PCI-SIG ENGINEERING CHANGE NOTICE

TITLE:	PCI Express Base PCI Bus Power Management Spec Updates
DATE:	January 7, 2005
AFFECTED DOCUMENT:	PCI Express Base Specification 1.0a
SPONSOR:	Ken Stufflebeam : Microsoft Corporation

Figure 7-16: Power Management Status/Control Register

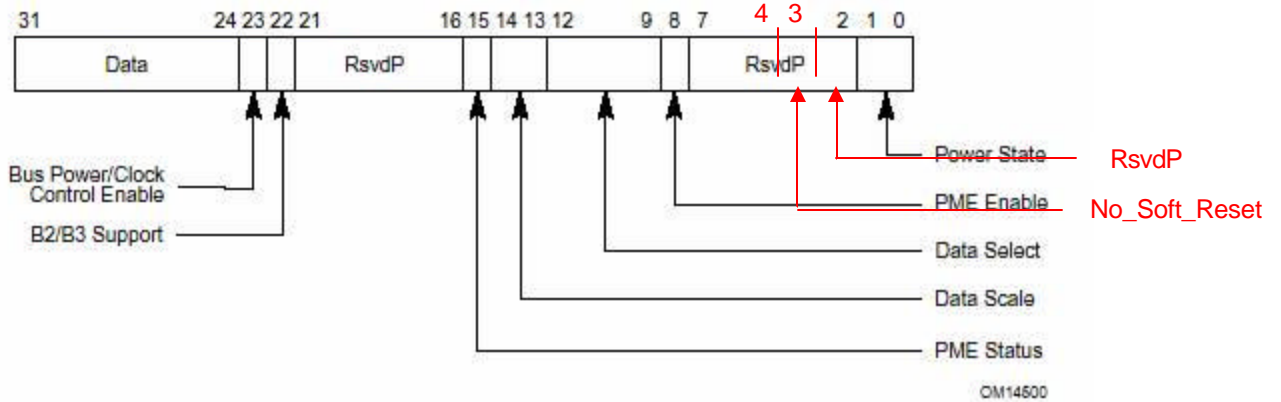
Figure 7-16 – corrected fields to reflect PCI Express reserved and No_Soft_Reset bits

Current Power Management Status/Control register does not show the new bits defined with revision 1.2. Since figure is included, it should be updated to reflect current configuration.

Add "No_Soft_Reset" and "Reserved for PCI Express" bits in Figure 7-16: Power Mangement Status/Control Register:
